SITE PLAN MODIFICATION
505 WEST CENTRAL STREET
LOT 3
(515 WEST CENTRAL STREET)
FRANKLIN
MASSACHUSETTS
FIELD CHANGE
PLAN

Date: February 1, 2024 Job No.: 10520.07
To: Ms. Breeka Lí Goodlander
Mr. Gregory Rondeau
Cc: Amy Love, Mike Maglio
From: Matt Crowley
Subject: **515 West Central Field Changes**

DATE: January 30, 2024
TO: Franklin Planning Board
FROM: Department of Planning and Community Development
RE: 515 West Central Street
Field Change

RE: *December 13, 2023 Memorandum from BETA Group, Inc.: 515 West Central Field Changes*

PROPOSED FIELD CHANGES

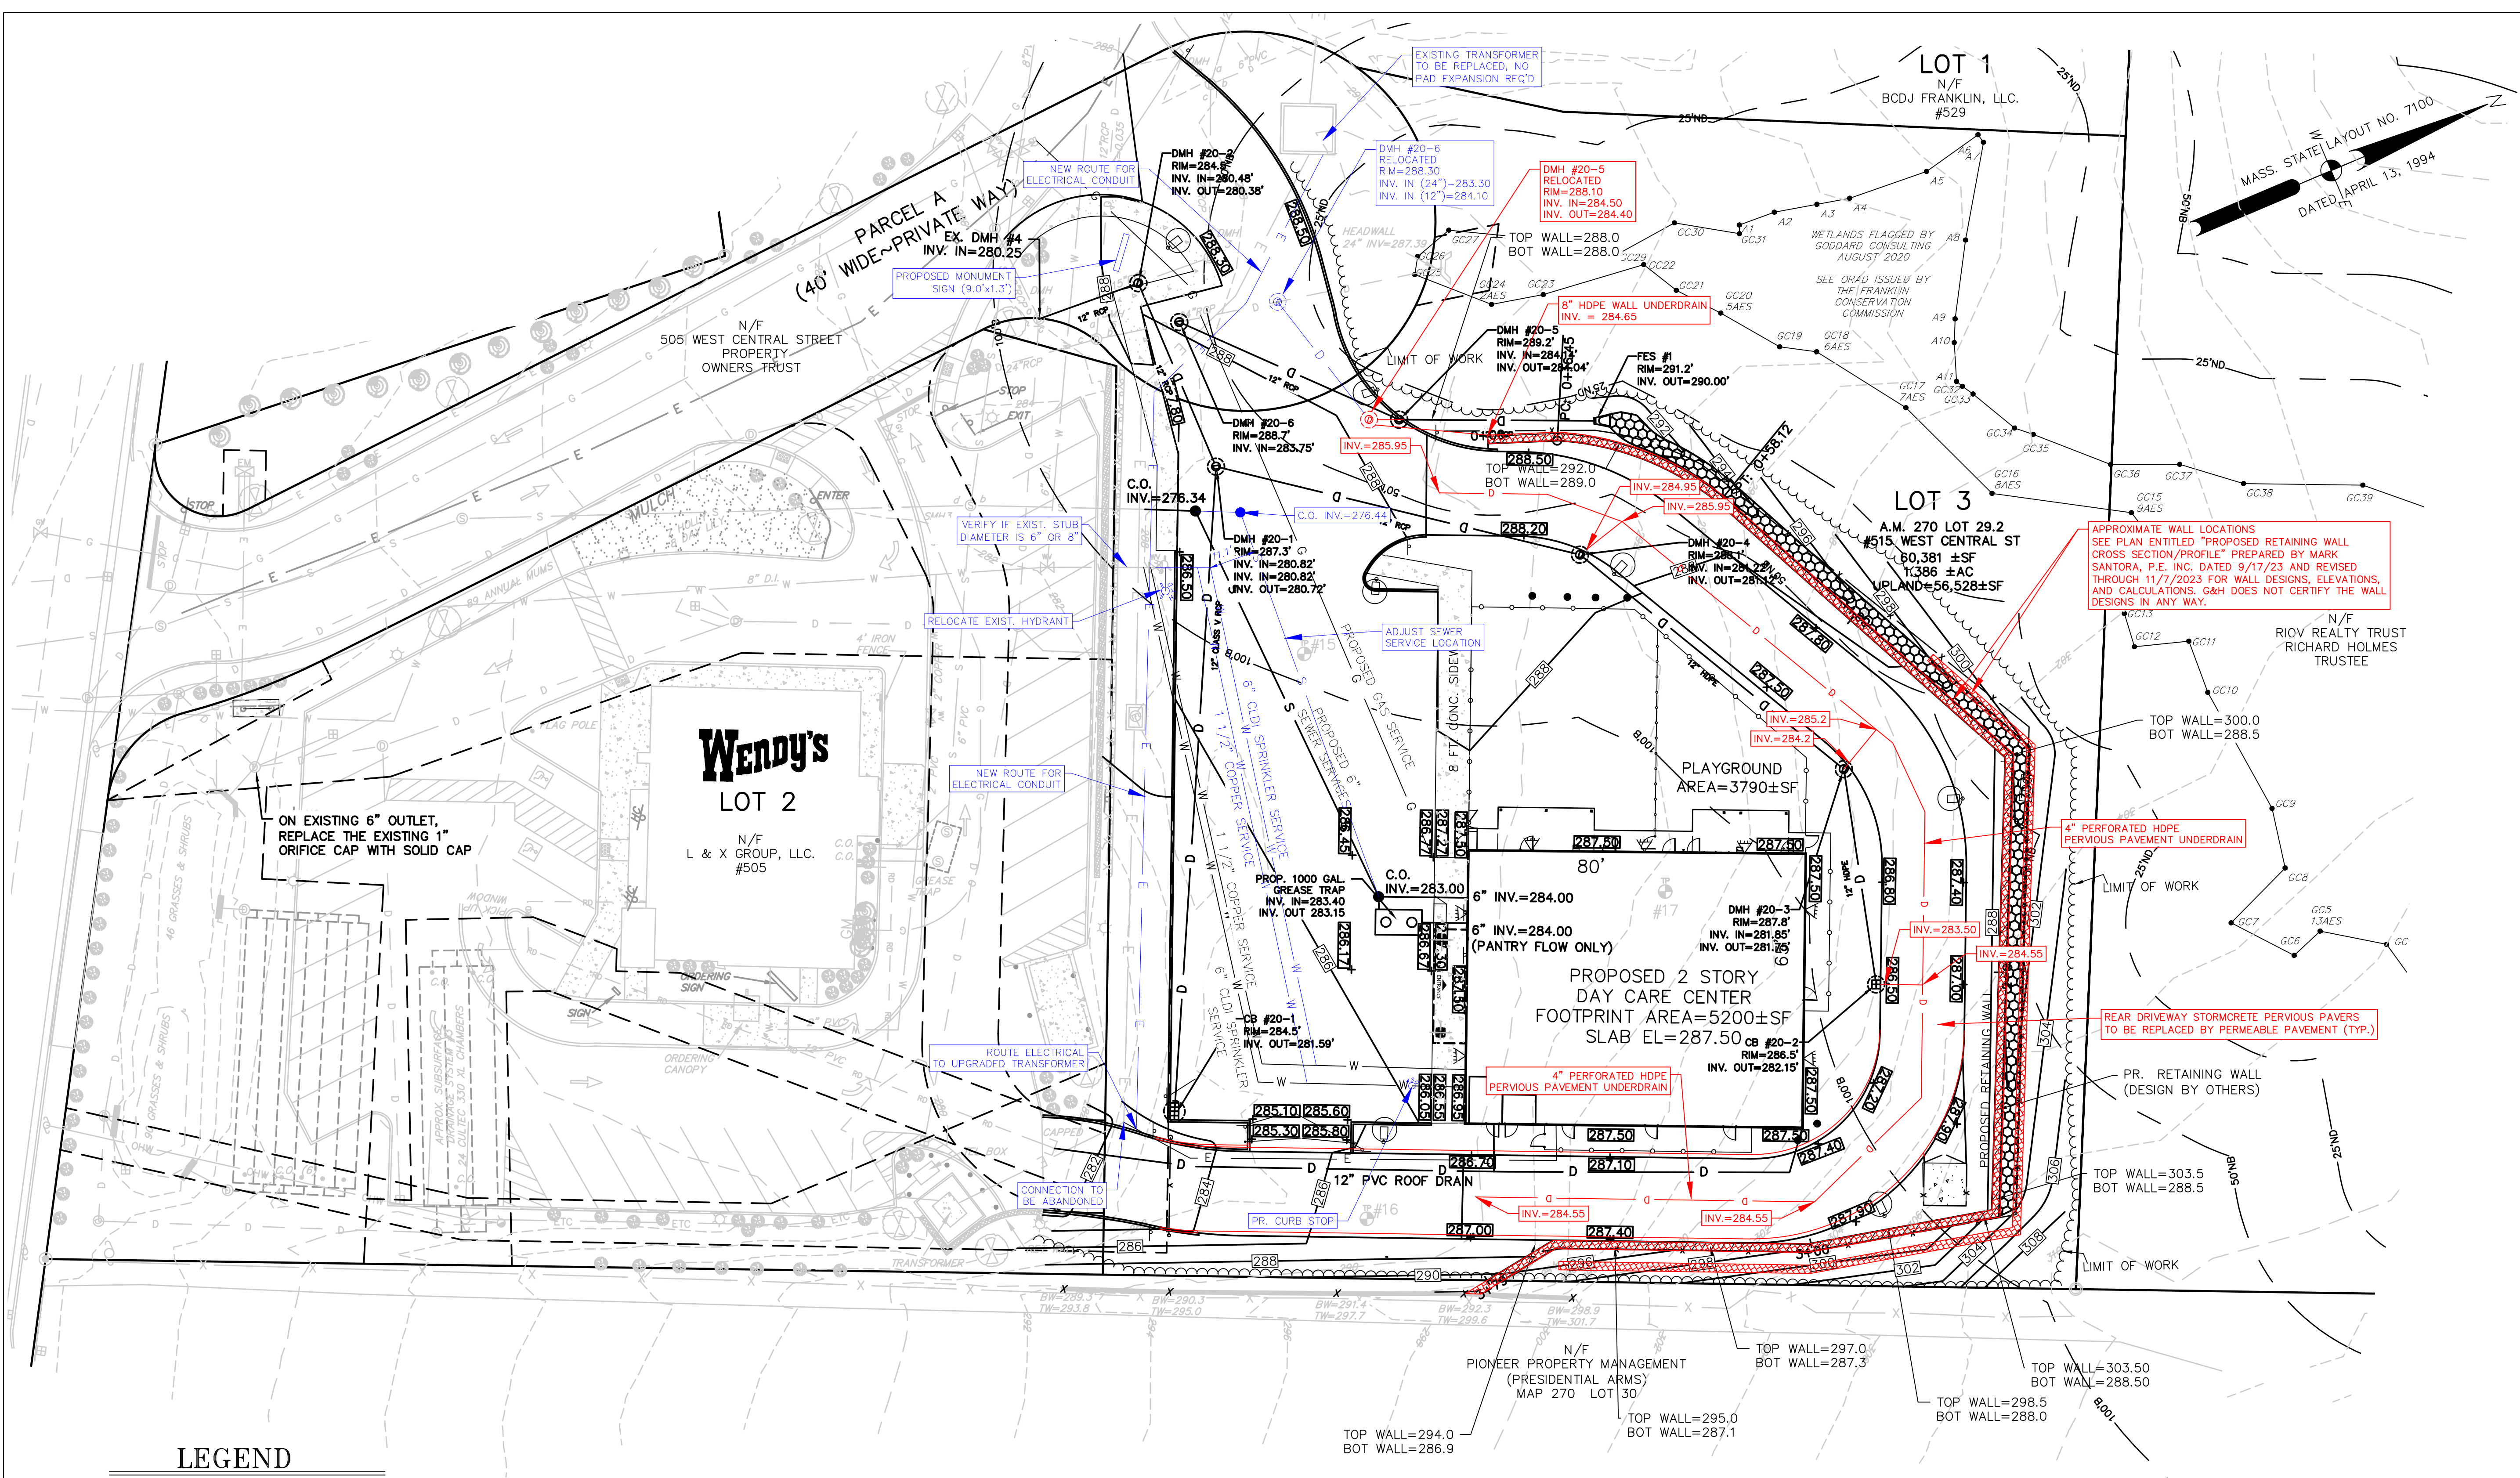
- STORMCRETE PERVIOUS PAVERS TO BE REPLACED BY PERMEABLE PAVEMENT. DUE TO LEDGE AND PERSISTENT HIGH GROUNDWATER BENEATH THE REAR ACCESS ROAD, INSTALLATION OF AN UNDERDRAIN CONNECTED TO THE STORMWATER CHAMBERS IS PROPOSED.

- THE PROPOSED WALL DESIGN IS TO BE A TERRACED DESIGN PREPARED BY MARK SANTORA, P.E. INC. INSTALLATION OF A SUBDRAIN 4" BELOW THE PROPOSED RETAINING WALL IS PROPOSED TO INTERCEPT GROUNDWATER ENTERING THE SITE, AND WILL CONNECT TO DMH #20-5.

- DMH#20-5 AND DMH #20-6 LOCATIONS ADJUSTED TO AVOID CONFLICTS WITH EXISTING AND PROPOSED UTILITIES.
- EXISTING TRANSFORMER AT SITE ENTRANCE TO BE UPGRADED, AND NEW ELECTRICAL SERVICE CONDUIT INSTALLED PARALLEL TO THE EXISTING RUN.

- FIRE AND DOMESTIC SERVICE CONNECTIONS TO BE MODIFIED TO ACCOUNT FOR FIELD CONDITIONS. CONTRACTOR TO VERIFY DIAMETER OF EXISTING STUB. EXISTING HYDRANT TO BE RELOCATED. SEWER SERVICE TO BE ADJUSTED TO MAINTAIN MIN 10" SEPERATION TO WATER SERVICES.

- MONUMENT SIGN PROPOSED AT SITE ENTRANCE.

PERVIOUS PAVEMENT CROSS SECTION
N.T.S.

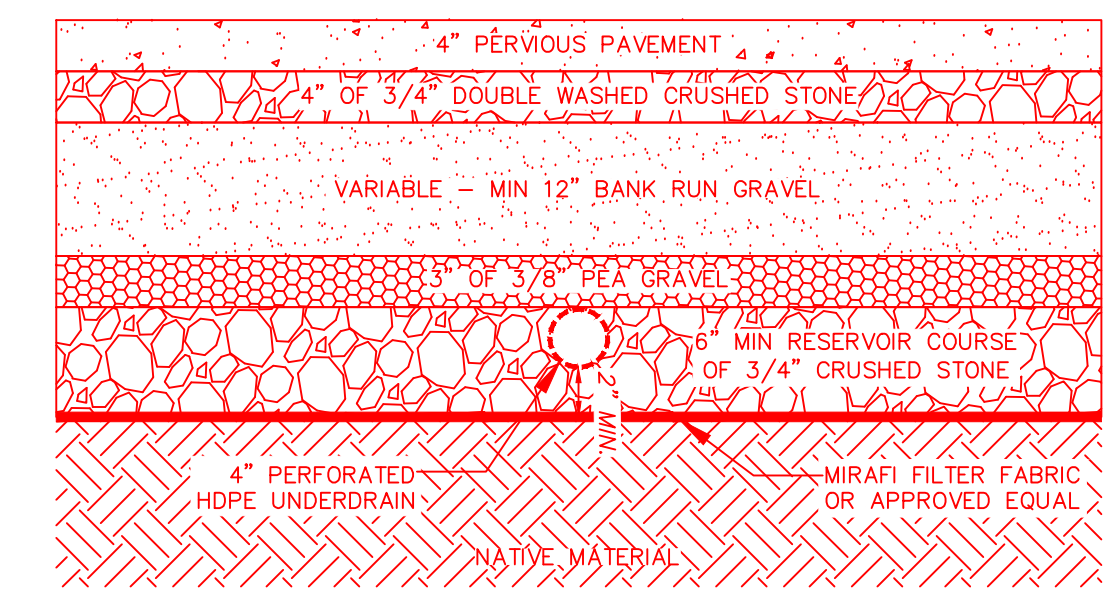
- The proposed pervious pavement detail is generally consistent with the Stormwater Handbook. Comments specific to the porous pavement are as follows:
 - The designer should confirm the proposed porous pavement thickness of 3" is suitable to support waste collection vehicle and fire apparatus loads. Porous pavement has a lower load-bearing capacity than conventional pavement. *G&H: The applicant has coordinated with BETA and revised the porous pavement detail to specify a 4" pavement thickness, placed in 2" lifts, to be consistent with the UNH Porous Pavement spec. BETA2: BETA defers to the Engineer of Record to confirm pavement has adequate load-bearing capacity – no further comment.*

- The bottom of the reservoir course should be flat, and it is recommended to raise the subdrain from the reservoir bottom to promote recharge when groundwater levels stabilize or are lower during the dry season. *G&H: The plans have been revised to provide a flat bottom, and the subdrain raised to promote recharge when conditions allow. BETA2: Design revised – issue resolved.*

- *The designer should confirm the proposed porous pavement thickness of 3" is suitable to support waste collection vehicle and fire apparatus loads. Porous pavement has a lower load-bearing capacity than conventional pavement.*

- *The bottom of the reservoir course should be flat, and it is recommended to raise the subdrain from the reservoir bottom to promote recharge when groundwater levels stabilize or are lower during the dry season.*

- NOTES:
- PERVIOUS PAVEMENT TO BE PLACED IN TWO 2" LIFTS
 - ALL GRAVEL & CRUSHED STONE TO BE WASHED.

- **The applicant has coordinated with BETA and revised the porous pavement detail to specify a 4" pavement thickness, placed in two 2" lifts, to be consistent with the UNH Porous Pavement spec.**

- **The plans have been revised to provide a flat bottom, and the subdrain raised to promote recharge when conditions allow.**
 - *The Operation and Maintenance Plan should be updated to reference the porous pavement and include specific maintenance requirements (e.g. power washing and vacuum sweeping). The approved O&M includes proprietary documentation for the porous concrete that is no longer applicable.*
